Amendment 01

Questions & Answers

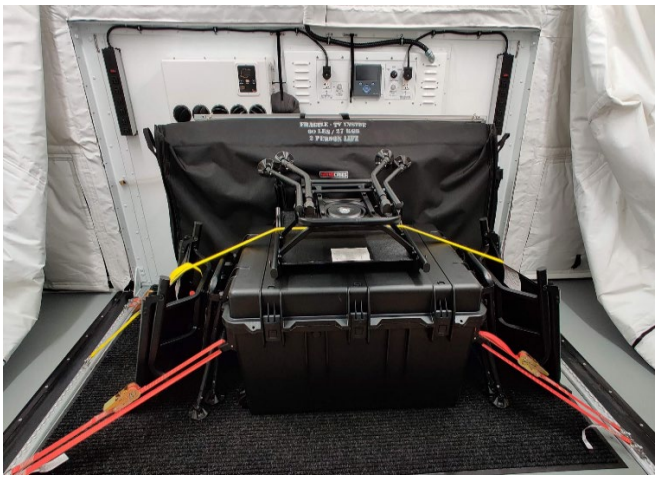
1. **<u>Question</u>**: On your second bullet under **Section 1.1 System Configuration and Mobility** reads**:**

"The design shall be containerized to protect internal components during transport."

A.) Are you calling for a separate custom container, unique from the Trailer/Command Center, which will house and protect the trailer/command center for transport? Or or...
   B.) Are you simply stating that the Command Center "shell" which is integrated onto the trailer chassis should be designed to protect the internal contents?

Solution A calls for two pieces of equipment to be designed, whereas Solution B would call for a single-piece solution.

<u>Answer</u>: B is the correct option. The sides should be hardened to protect the internal tent. The floors to the tent should fold up to create a protective shell during transportation.
